Scope:

DESIGN AGENCY	WOOLPERT
DESIGNER	AC
REVIEWER	SJB
PROJECT ID	1-3-24
SHEET	0
TOTAL	0
P.O.	0

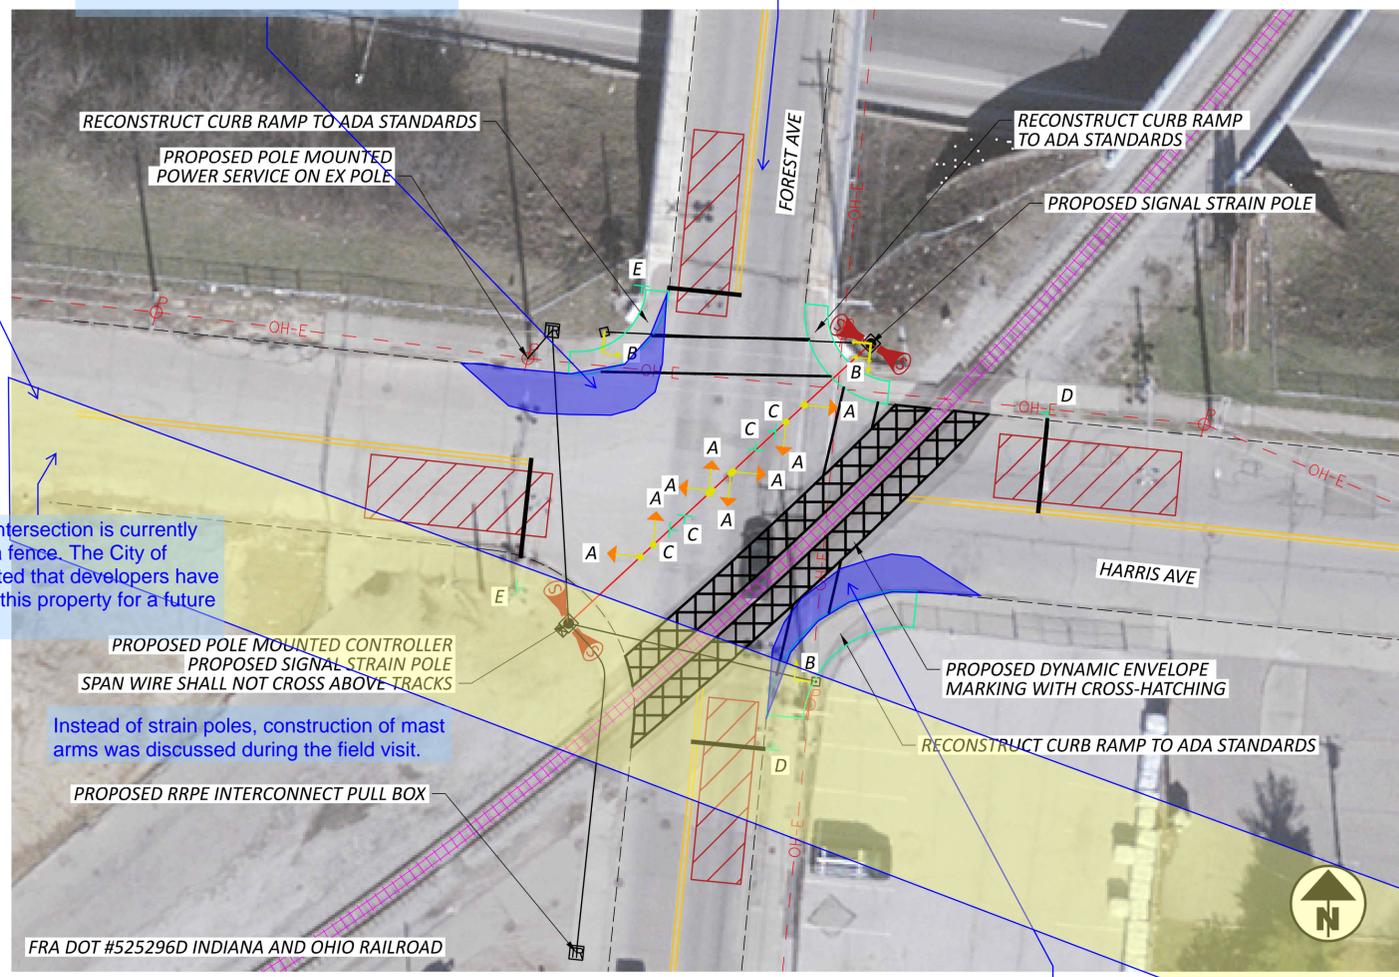
Clint Zimmerman with the City of Norwood explained that there is an existing subway tunnel under the intersection. He thinks it's generally located in the yellow highlighted area.

Clint will try to find plans. The project will need to verify the location of the tunnel to ensure signal pole foundations placement avoids the tunnel.

A curb bumpout could be considered here to make space to construct a signal pole foundation further away from the bridge abutment and slope grade break.

It was noted that there is another project that will rehab/replace this bridge.

This leg of the intersection is currently closed off with a fence. The City of Norwood indicated that developers have been looking at this property for a future office building.

Instead of strain poles, construction of mast arms was discussed during the field visit.

Vehicles from the south leg and the east leg were observed taking turns squeezing through this area while an active train was stopped on the tracks.

Suggest constructing a curb bump out here to block vehicles from making this movement when a train is on the tracks.

If the alignment on this image is accurate, the tunnel is not under the intersection.

CAGIS shows historic property lines south of the intersection. I suspect this is showing the alignment of the tunnel. The tunnel must curve through or after the intersection.
